Planning and Zoning Board

GENERAL PLAN CASE #: GPMInor14-005
CASE NUMBER: Z14-016 PLN2014-00008
LOCATION/ADDRESS: The 5000 to 5200 blocks of East Brown Road (north side).
GENERAL VICINITY: Located at the northwest corner of Brown Road and Higley Road
GENERAL PLAN REQUEST: Minor General Plan Amendment to adjust the boundaries of the existing Mesa 2025 General Plan Land Use designation from NC to MDR 4-6 (5± gross acres)
ZONING REQUESTS: Rezone from AG to RSL4.5-PAD on 43.65± acres and Rezone from AG to RSL2.5-PAD on 33± acres and Preliminary Plat approval.
PURPOSE: This request will allow the development of a single-residence subdivision with 431 lots of varying sizes.
COUNCIL DISTRICT: District 5
OWNER: Tallact, LLC., Anthony Perricone
APPLICANT: Andrew Gasparro, KB Homes and Sean Lake, Pew & Lake LLC.
STAFF PLANNER: Angelica Guevara

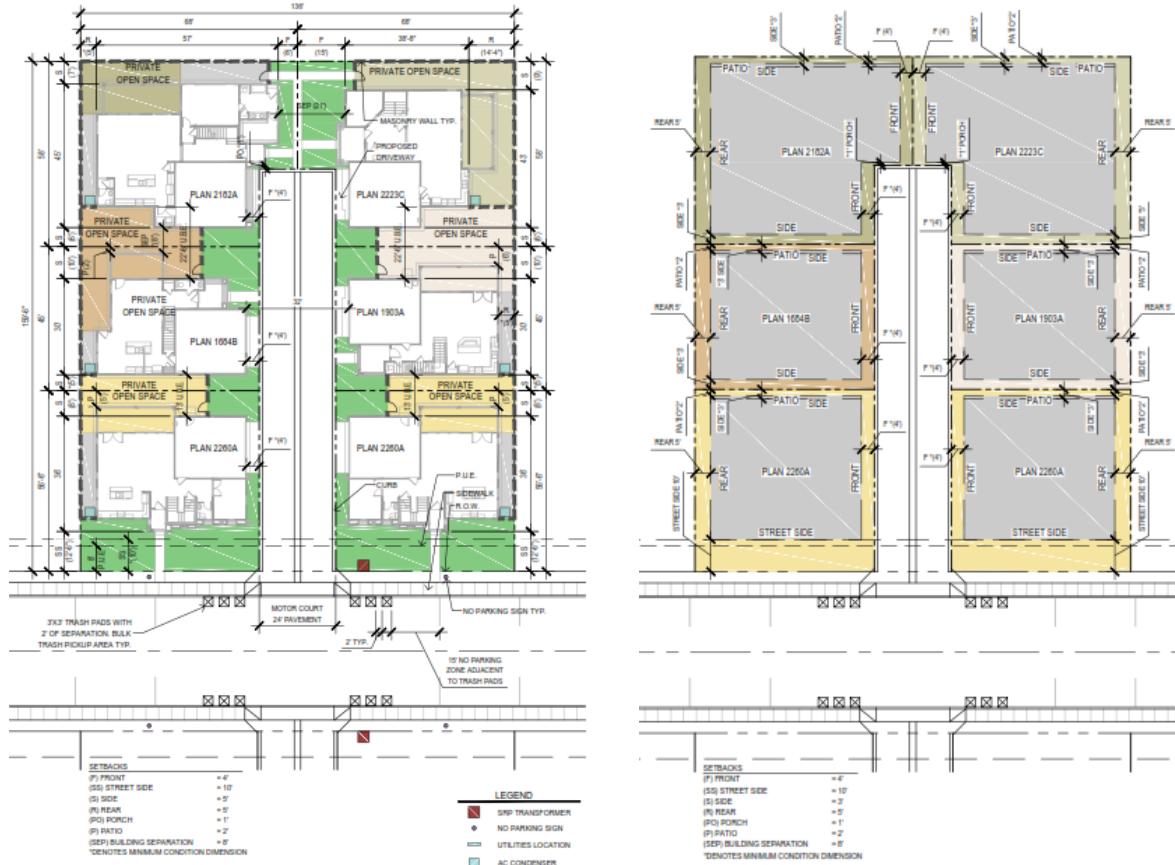
Staff is concerned with the proposed 5-foot rear setback for the cluster product which will be 2-stories in height with only 10 feet between homes. The exhibit provided on the following page from the applicant's submittal, on the left identifies the proposed unit mix within a cluster. The exhibit on the right, identifies the minimum setbacks proposed for a cluster. Staff would like to ensure that the layout and massing on the left is what will actually be constructed. The concern is with the 5-foot rear yard setback if product is constructed to the setbacks. Staff is less concerned with the area between the homes because that is where the required on-lot usable space, identified with a Use and Benefit Easement, which is established with in the Zoning Ordinance as a minimum of 280-400 square-feet. This ensures that there will actually be useable private area between the homes. Staff is proposing a possible solution which would limit the amount of solid wall along the rear property line to a maximum of 55% percent of the length of the cluster. The remainder of the building wall would need to be at the 10-foot setback. Staff has included a stipulation of approval to address this concern.

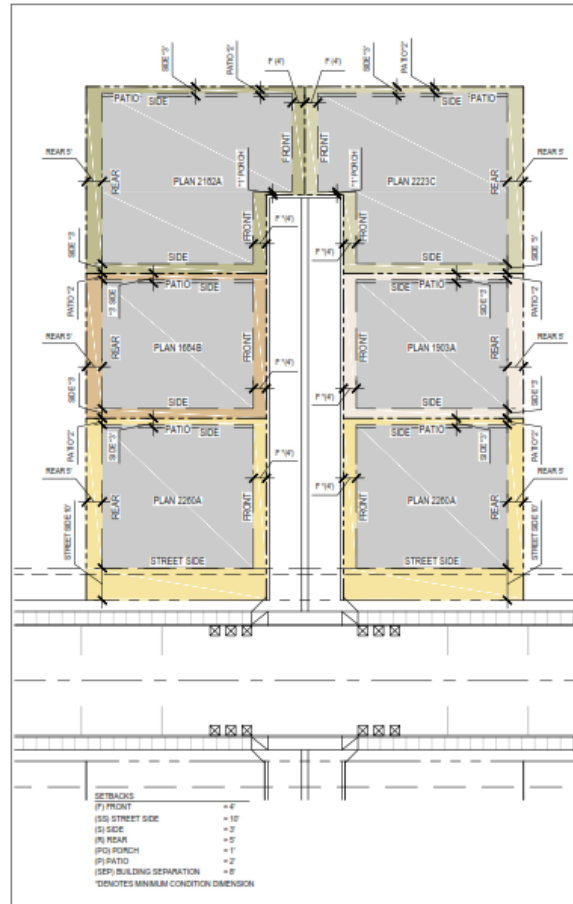
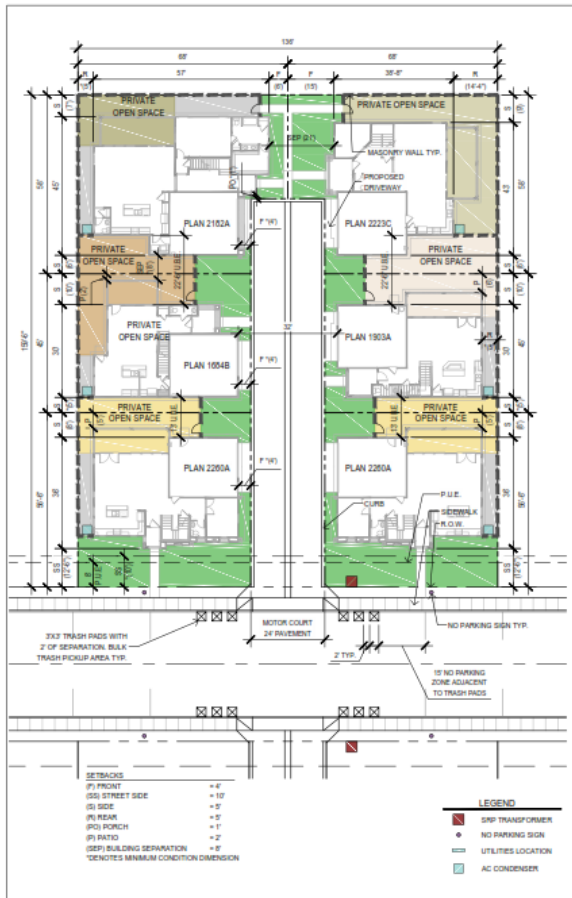
The applicant is proposing to change the General Plan land use designation at the corner of Higley and Brown from NC to MDR 4-6. Having commercial development at this corner would allow for development of a small convenience center that would serve the daily needs of the adjacent residents. This would help meet goals of providing for local shopping needs within walking distance of homes. However, there are two community commercial centers to the southwest and southeast of the site that struggle to remain fully occupied, thus indicating additional commercial uses are not needed in the area. By allowing the change to the Plan we would not be increasing the amount of commercial use and adding to the customer base of the retail space to the south. Staff is supportive of allowing the modification in the General Plan designation if the proposed development will be designed to help encourage pedestrian traffic to the commercial areas to the south.
